INSPECTION LIST REVISION #2 (SNAG LIST @ PC)

STELLENBOSCH UNIVERSITY

COETZENBURG STADIUM ADDITIONS & ALTERATIONS
ELECTRICAL SERVICES

15 June 2023

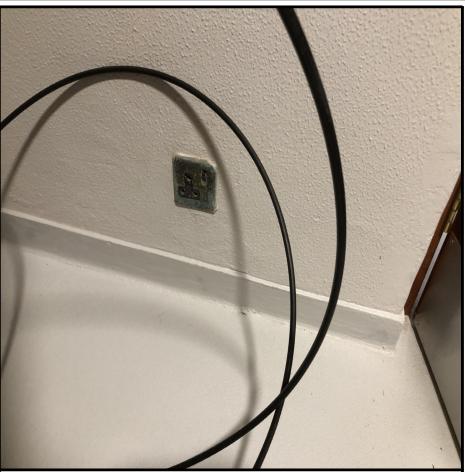
865.LAN point route to be completed.

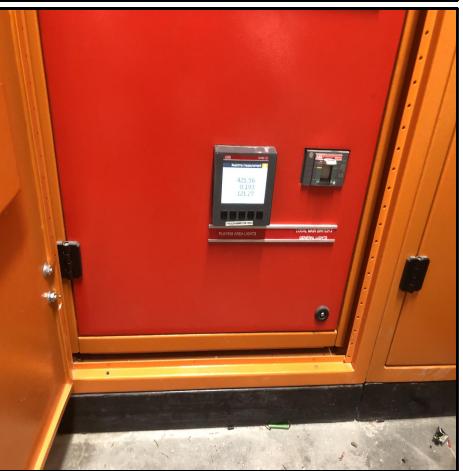
908.Two fans not working SUN property services to address. Fan 5 and 7 to be disconnected in the meantime for safety.

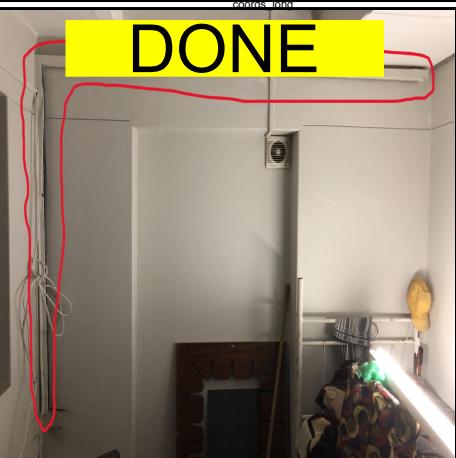
Redundant isolators to be disconnected and removed.

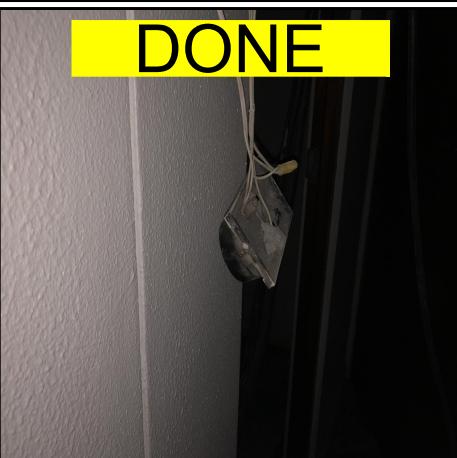
Room 1 - Please cut and remove redundant cabling and surface trunking up to wall penetration.

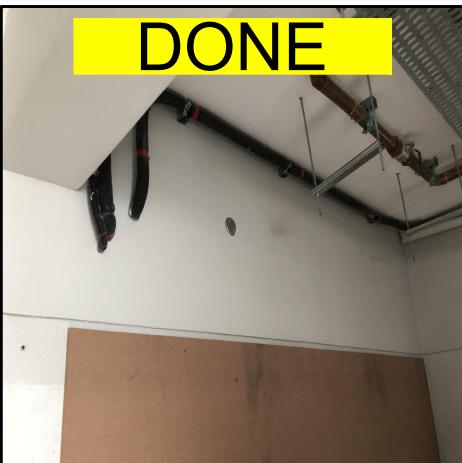
West toilets in changeroom. Missing screw.

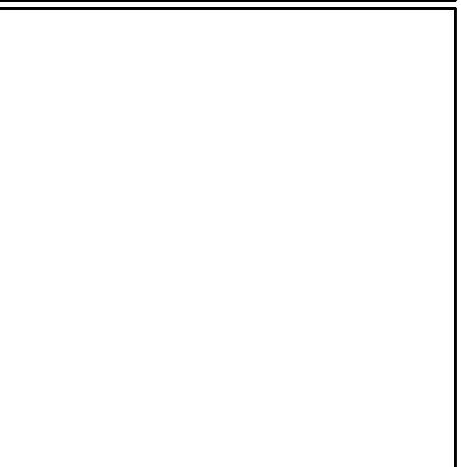
MDB internals to be dust free.

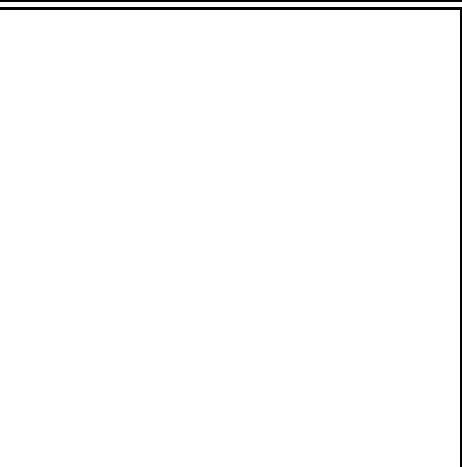
Please tuck redundant circuits in MDB out of way and end with heat shrink.

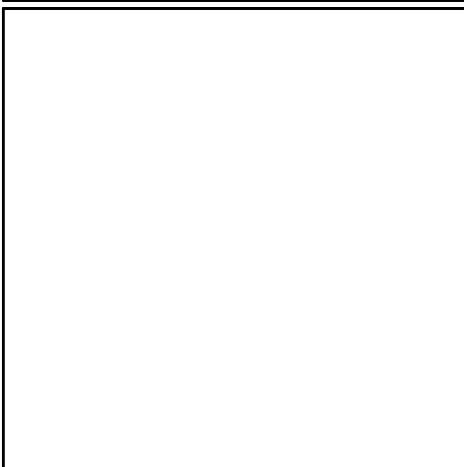
MDB room to be cleaned and painted.

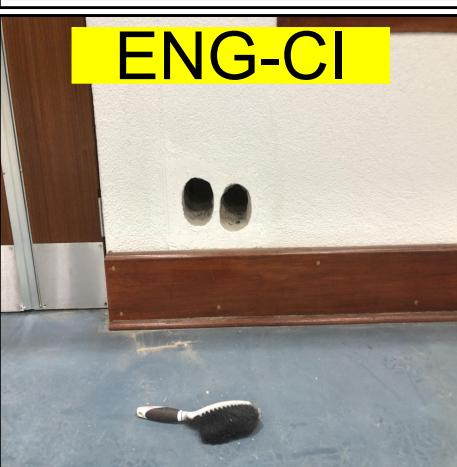
945.Cover plate missing. Engineer to check if this was issued.

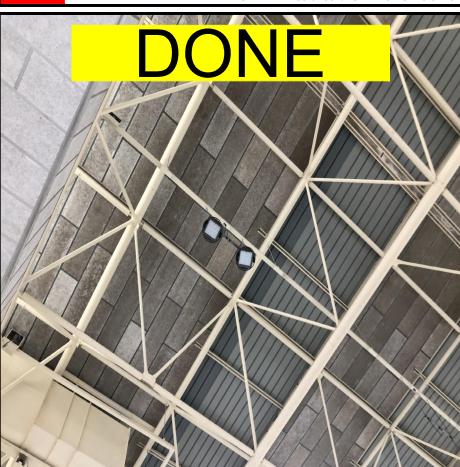
Method to connect vertical conduit to manhole to be discussed on site.

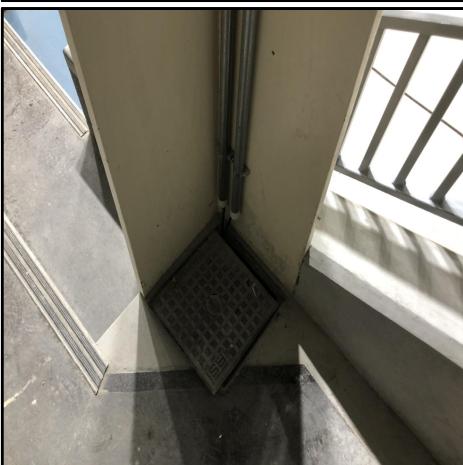
818.Fibre splice missing.

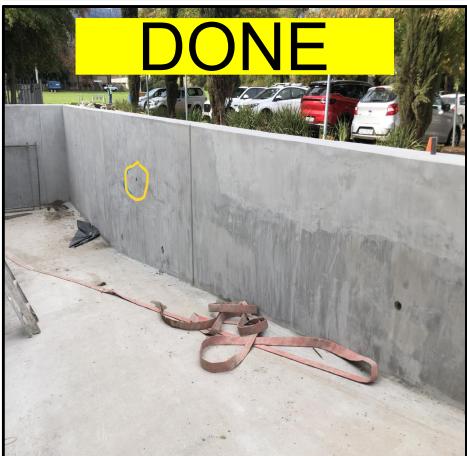
Missing ramp lighting. Points must be at or below grade.

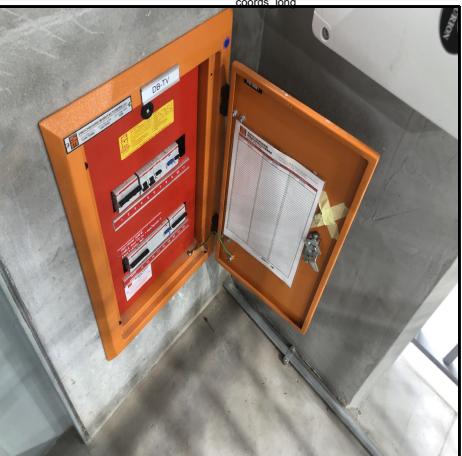
Please fix conduit to wall. Please advise if CI required.
